Customer :	CU-DAR001 Dart Helicopters Services	Drawing Name :	350 SKIDTUBE ASSEMBLY LH
Job Number :	38728		
Estimate Number :	10266		
P.O. Number :		Part Number :	D350636013
This Issue :	22/04/2008	S.O. No. :	
Prsht Rev. :	NC	Drawing Number :	D2750 REV E
First Issue :	11	Project Number :	N/A
Previous Run :	37559	Drawing Revision :	E
	Type :	Material :	
	LANDING GEAR	Due Date :	15/05/2008
Written By :		Qty:	1 Um: Each
Checked & Approved By :	<u>JLD 08.4.22</u>		
Comment :	Est Rev:H 02.09.25 Rearranged procedure steps KJ est rev I 06.03.30 Per rev. D dwg EC Est Rev:J 07-07-28 Added SS Wearplates(Rev E) JLM Verified By:EC

DART SERVICE INSTRUCTION

TO AMEND INSTALLATION INSTRUCTIONS IIN-D350-636 REV E

FOR D350-636-011/-012/-013/-014 SKIDTUBES AT CHG 004:

FIGURE 1 - D350-636-011/-012/-013/-014 AT CHG 004 AND INSTALLATION OF DSI 9413-011
(LOCATION OF AN526C1032RXX SCREWS ARE NOT TO BE USED TO MOUNT WEARSHOES)

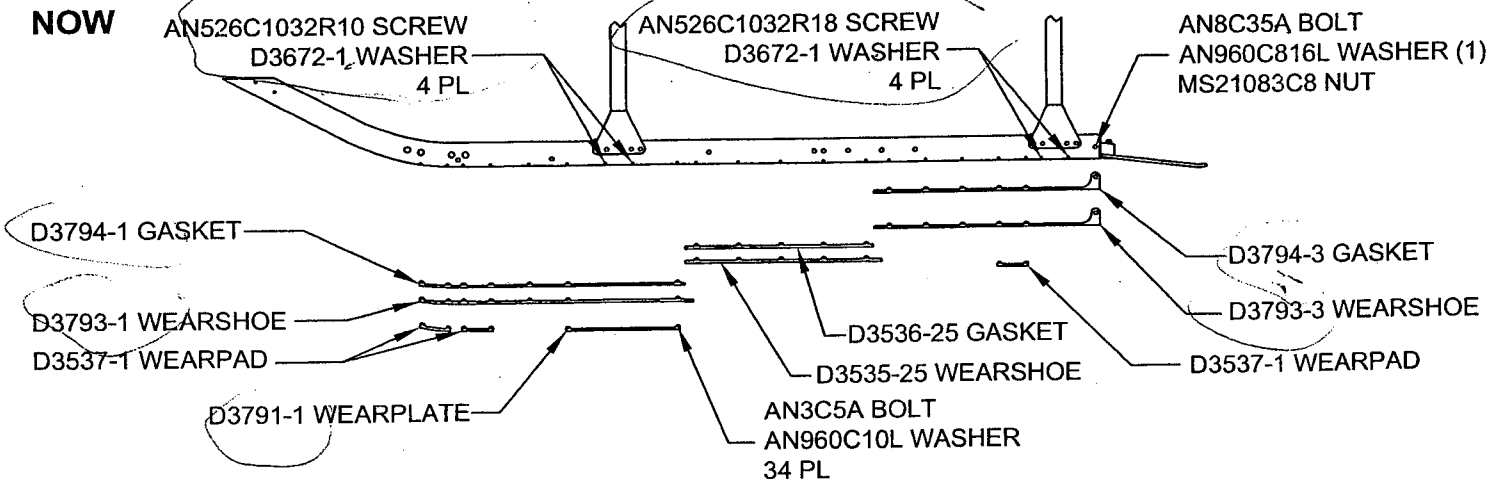
TO IMPROVE THE INSTALLATION OF THE DART D350-636-011/-012/-013/-014 SKIDTUBES ONTO THE CROSSTUBES, THE INSTALLATION AND PART NUMBERS OF THE FWD AND AFT WEARSHOES/GASKETS HAVE BEEN REVISED AS SHOWN IN FIGURE 1 BELOW.

FOR EXISTING CUSTOMERS THAT WOULD LIKE TO IMPROVE THE INSTALLATION OF THE SKIDTUBE TO THE CROSSTUBE, REFER TO PAGE 3 OF THIS DOCUMENT
